File Ref: U045-04-01
Date: 22 February 2023
Memo To: Paul Whyte

Subject: Proposed Residential Plan changes 2022 Servicing – Three Waters and Transport

(Report prepared by Brett Walker)

2. S Clifford - Schematic for servicing

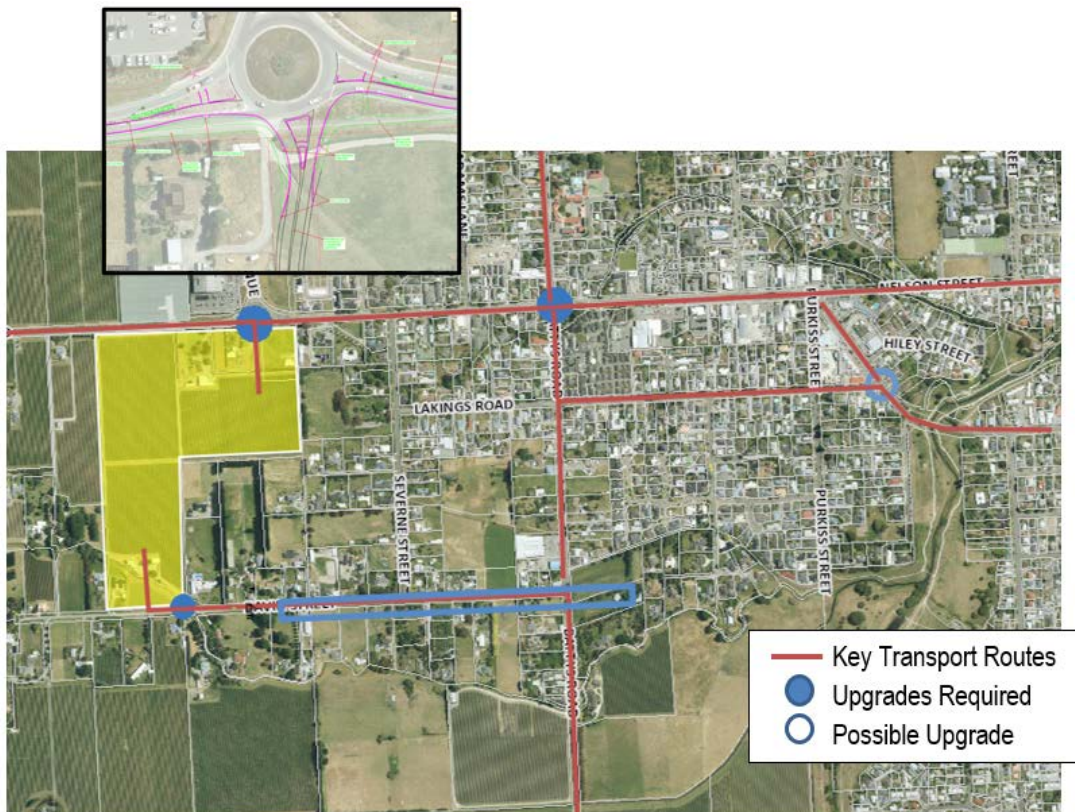
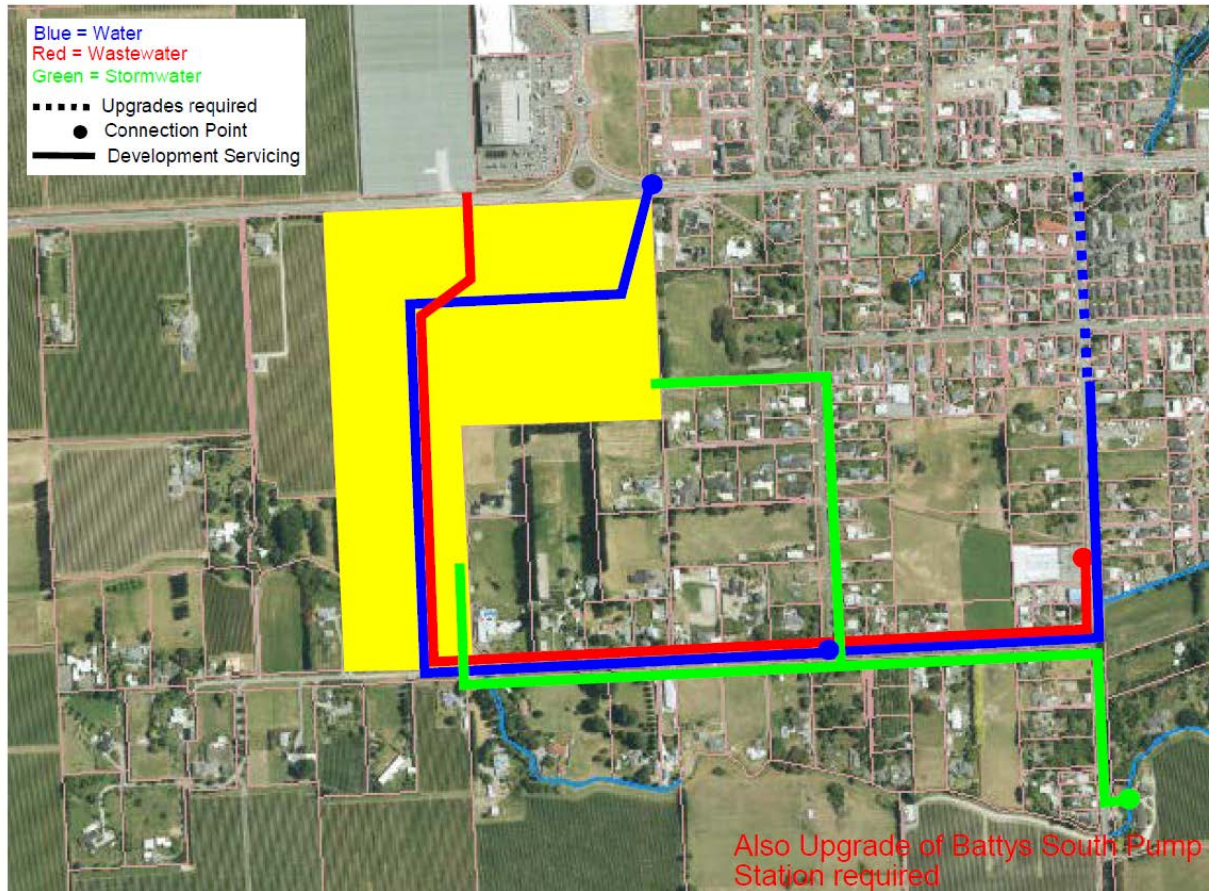
- Connection Points
 - Westwood Avenue
 - Severne / David Street – proposed watermain
- Upgrade / new infrastructure requirements to provide local capacity
 - Watermain upgrade along Battys Road (Middle Renwick to 80m south of Lakings)
 - Installation of a Watermain along Battys Road (80m south of Lakings to David)
 - Installation of a Watermain along David Street (Battys to Severne)
- Other information
 - Installation of larger infrastructure linkages within the site for benefit of other development.

- Connection Points
 - Battys Road “North” Wastewater Pump Station
- Upgrade / new infrastructure requirements to provide local capacity
 - Battys Road “South” Wastewater Pump Station (Larger capacity pump station).
 - Springlands Green Wastewater Pump Station (Changes to controls)
 - Upgrade / new infrastructure requirements to provide local capacity
 - Installation of a Wastewater main along David Street to Battys Road “North” Pump Station.
- Other information
 - Installation of larger infrastructure for benefit of other development
 - Extensions of infrastructure for future connection to the land to be developed to the west of Westwood.

- Connection Points
 - Old Fairhall Stream.
- Upgrade / new infrastructure requirements to provide local capacity
 - Installation of trunk stormwater mains within David Street, Severne Street and Battys Road.
- Other information
 - Installation of stormwater attenuation ponds to restrict discharges to an equivalent to predevelopment runoff required.
 - Installation of stormwater treatment required
 - Extensions of infrastructure to the West to convey existing runoff through the development.

- Installation of a stormwater pump station downstream of Battys Road may be required.
- Construction of Roads as secondary flow paths to convey residential stormwater from the west through the development.

- Connection Points
 - Fourth leg on the existing roundabout on SH6 – will require Waka Kotahi to approve.
 - David Street
 - Active transport connection through Severne Park to Lakings Road

- Upgrade / new infrastructure requirements to provide local capacity
 - The SH6 roundabout will require upgrading as a result of undeveloped land. Additional upgrading will be required as a result of this subdivision. While preliminary drawings from the applicant's consultant (refer Appendix 2) show the central island in the same location, it is considered the roundabout will require a full rebuild, with two circulating lanes. The upgrade should be partially funded by Waka Kotahi however the bulk of the upgrade (relocating central island and fourth leg) will be due to the re-zone.

- David Street will need to be widened, kerb and channel installed and footpaths installed. The existing one-lane bridge should be widened.
 - The Murphys/Battys/Middle Renwick Road roundabout will require upgrading as a result of undeveloped land, however additional upgrading will be required as a result of this subdivision.

- Other information
 - Marlborough Roads is also concerned about Lakings/ Boyce Street intersection as this is the quickest route to the town centre from David Street, however delays here may result in additional traffic using the Murphys/ Battys roundabout

- The connection to Middle Renwick Road needs to be built to at least collector road standard.
 - Council has received a draft Traffic Impact Assessment for S Clifford, however as at 8 November, it fails to adequately assess the effects of the plan change above the already re-zoned land and development potential. The consultant is going to update their analysis.

3. Kerepi - Schematic for servicing

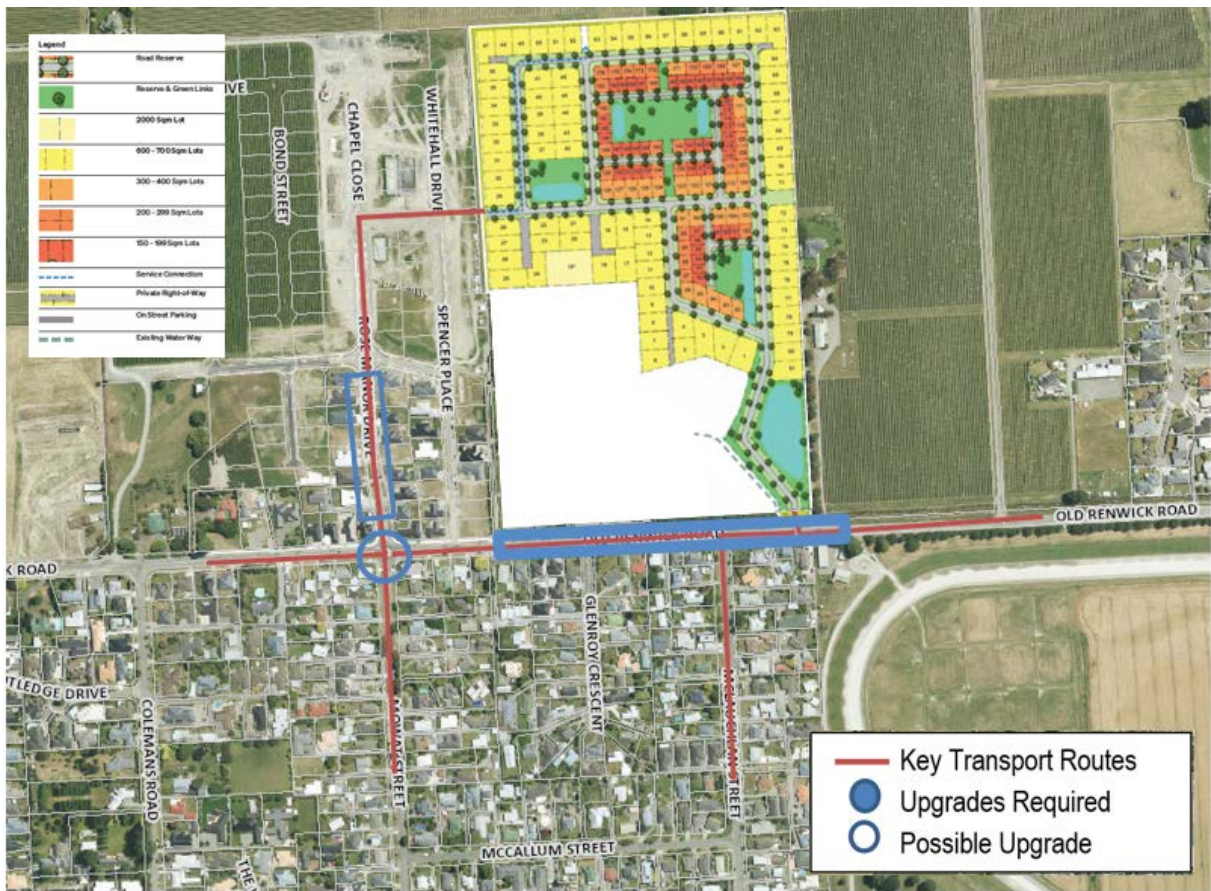
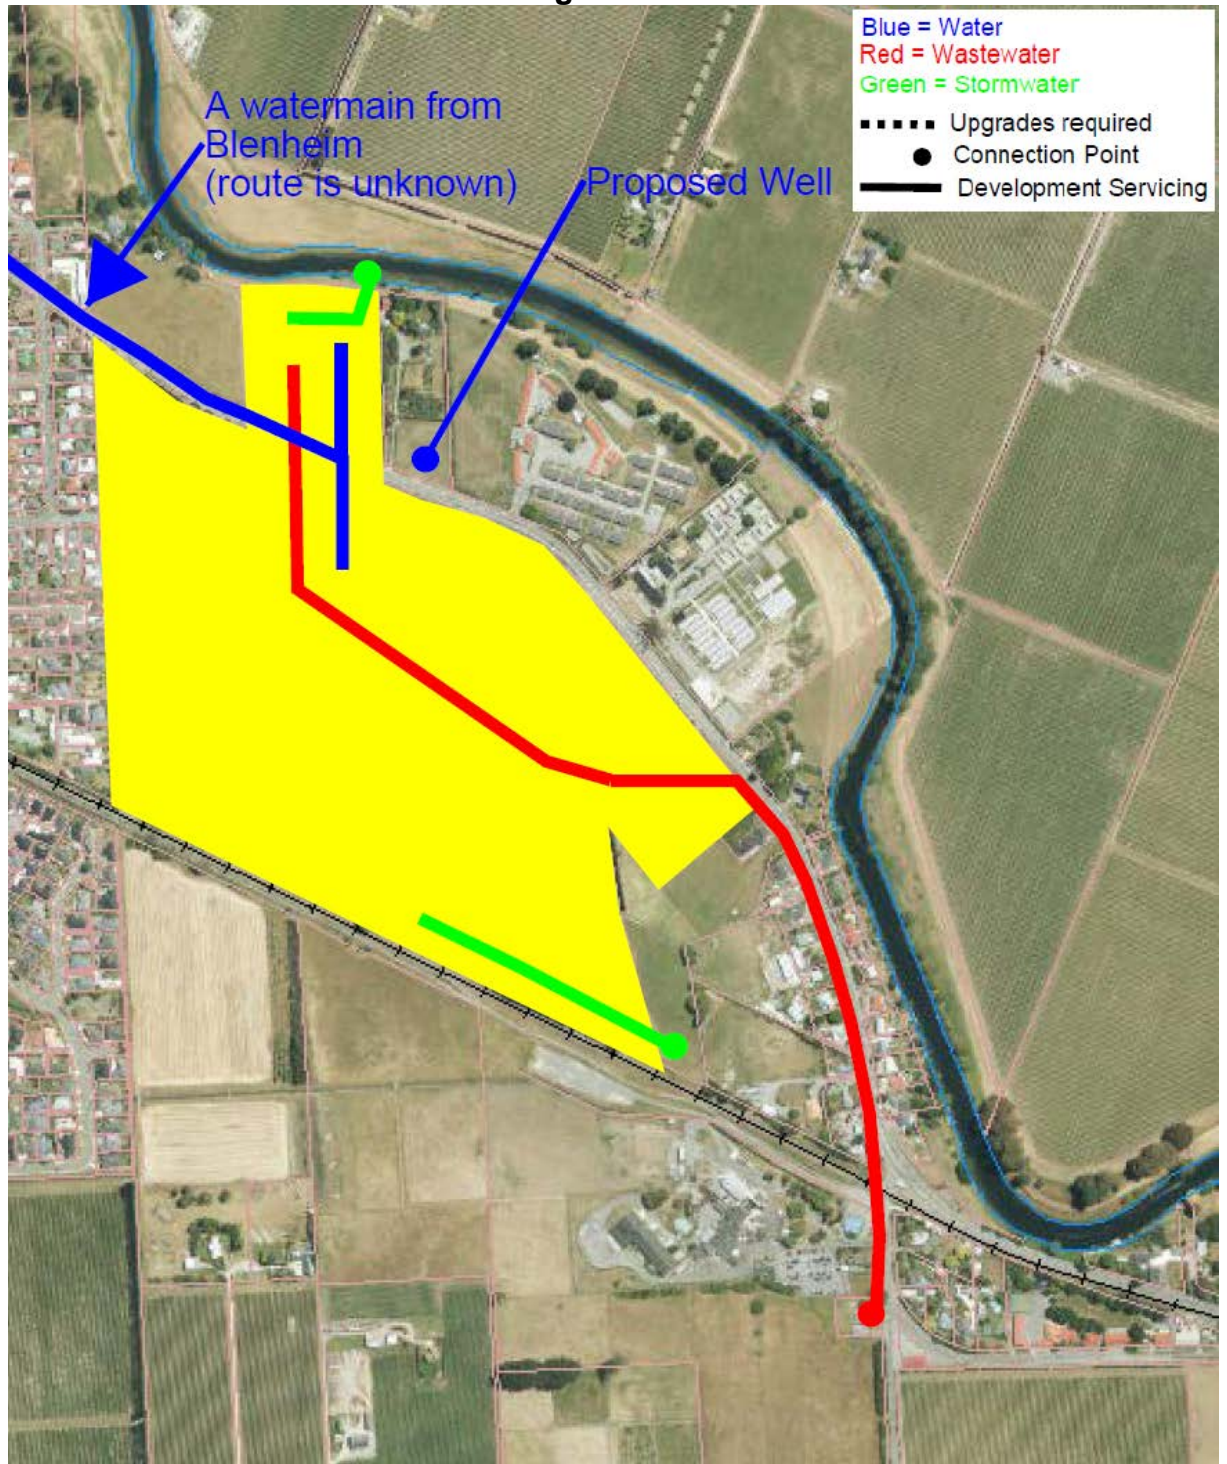
- Connection Points
 - McLauchlan Street – proposed watermain
 - Oakley Avenue – existing watermain
 - Waipuna Street – existing watermain
- Upgrade / new infrastructure requirements to provide local capacity
 - Installation of a Watermain for the full length of McLauchlan Street
 - Installation of a Watermain along Old Renwick Road (McLauchlan to Waipuna)
- Other information
 - Installation of larger infrastructure linkages within the site for benefit of other development.
 - Reimbursement of cost for water infrastructure installed by Council within property to the west.

- Connection Points
 - McLauchlan Street Wastewater Pump station – located 450m south of site
- Upgrade / new infrastructure requirements to provide local capacity
 - Installation of a Wastewater main to the McLauchlan street Pump Station.
- Other information
 - Installation of larger infrastructure for benefit of other development required.

- Connection Points
 - Caseys Creek – southern end of the site, upper Opaoa River.
- Upgrade / new infrastructure requirements to provide local capacity
 - Possibly Caseys Creek pump upgrade.
- Other information
 - Installation of stormwater attenuation ponds to restrict discharges to an equivalent to predevelopment runoff required.
 - Installation of stormwater treatment required.
 - Construction of Roads as secondary flow paths to convey residential stormwater from the west through the development.
 - Check of Caseys Creek pump outfall capacity is required.

- Connection Points
 - Old Renwick Road
 - Oakley Avenue
- Upgrade / new infrastructure requirements to provide local capacity
 - Analysis of the Rose Manor roundabout has not been done for this subdivision, however previous analysis shows that this roundabout is satisfactory to take additional traffic from development to the west until a connection to Thompsons Ford Road is created.
 - Rose Manor Drive has been constructed as a local road and should have been constructed as a Collector Road. No parking lines will probably need to be painted.

- Continued upgrading of Old Renwick Road (between #63 and east of site) to achieve a 10.9m wide carriageway. A right turn bay will be required into the site as there will not likely be room for a roundabout due to Caseys Creek
 - Footpath on northern side of Old Renwick Road required.
- Other information
 - A preliminary internal road layout was provided to council and included in Appendix 3.
 - It is likely that the McLauchlan/Nelson Street intersection will be upgraded as part of the Marlborough School Project.
 - The connection to Old Renwick Road needs to be built to at least collector road standard

4. St Andrews - Schematic for servicing

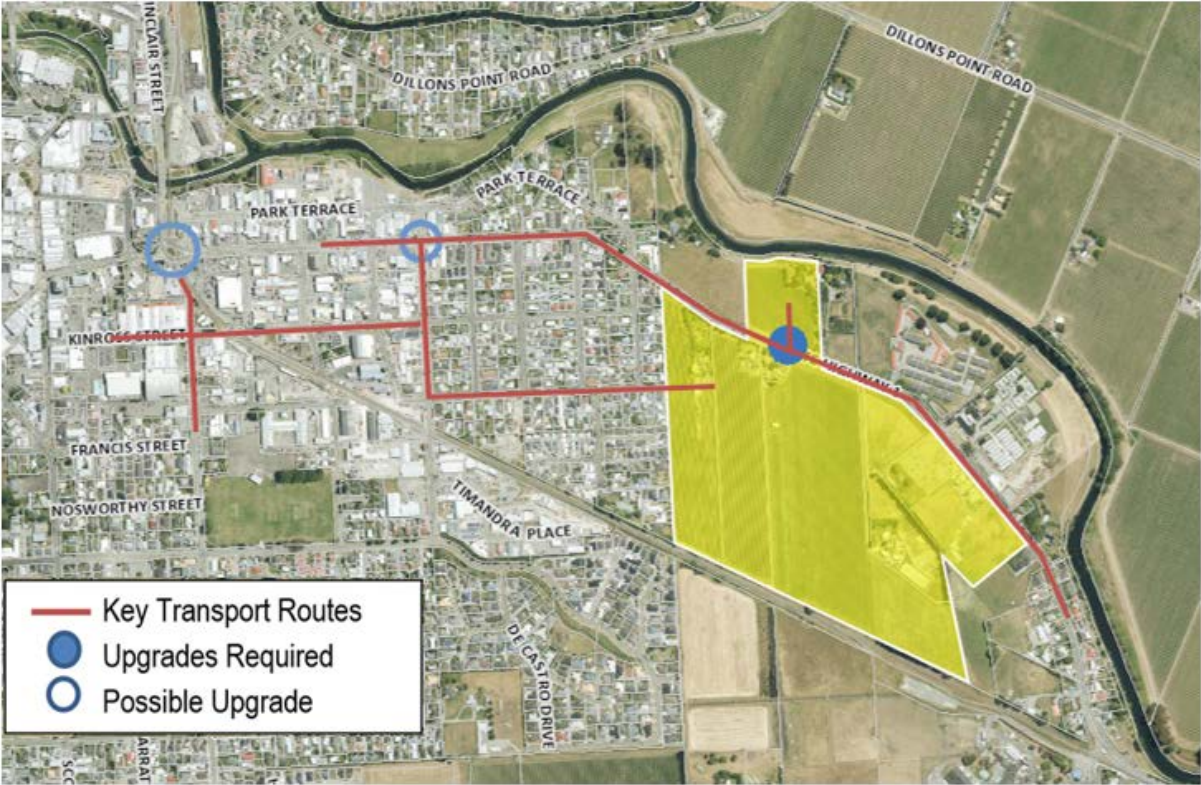
- Connection Points
 - To an undefined trunk main within the Blenheim area.
 - Proposed Well / Treatment site SH1 by Council.
This thought is only at a preliminary stage and requires a review of concept and Resource Consent approval.
- Upgrade / new infrastructure requirements to provide local capacity
 - Installation of a Watermain to the connection point within the Blenheim area.
 - Blenheim Network upgrades as a direct result of this site.
Extent currently unknown.
 - Installation of Well's / Treatment within the Council site SH1.
Pending review of concept.
- Other information
 - Installation of larger infrastructure within the individual sites for benefit of other developments, ie: Riverlands.

- Connection Points
 - Main Outfall Pump Station (MOPs) at Alabama / Schools Road.
- Upgrade / new infrastructure requirements to provide local capacity
 - Main Outfall Pump Station (MOPs) pump upgrades.

- Connection Points
 - Catchment on northern side of SH1 to the Opaoa River.
 - Catchment on southern side of SH1 to the New Snowdens Basin.
- Upgrade / new infrastructure requirements to provide local capacity
 - Installation of trunk stormwater mains throughout the proposed Plan Change area to the connection points.
 - Snowdens stormwater attenuation basin must be completed prior to completion of first stage of this development.
- Other information
 - Installation of stormwater attenuation ponds to restrict discharges to an equivalent to predevelopment runoff required.
 - Installation of stormwater treatment required.
 - Installation of stormwater pumps may be required to maintain discharges during higher receiving water levels.
 - Construction of Roads as secondary flow paths to convey residential stormwater from the west through the development.

- Connection Points
 - SH1 – likely to be a new roundabout. Will require Waka Kotahi to approve.
 - South Street
 - Active transport connections to Whale Trail
- Upgrade / new infrastructure requirements to provide local capacity
 - New roundabout n SH1 – to be paid fully by development levies from re zone

- Possible signalisation of SH1/Stuart Street noting there are issues already here and will get worse. This will require Waka Kotahi approval as it is a state highway
- Additional traffic will likely add to issues at Sinclair/Main roundabout
- Consideration to upgrade SH1 with pedestrian facilities – this will assist with the RSE workers site at 3023 and 3043.
- Extend the 50 km/h speed limit to past the site connection (note that more connections to SH1 will reduce the speed, but something Waka Kotahi will need to approve)
- Other information
 - It is unlikely that Waka Kotahi will allow for more than one access point. The applicant's agents agree with this.
 - The connection to SH1 needs to be built to at least collector road standard
 - Additional traffic on Kinross Street rail crossing may require KiwiRail consultation
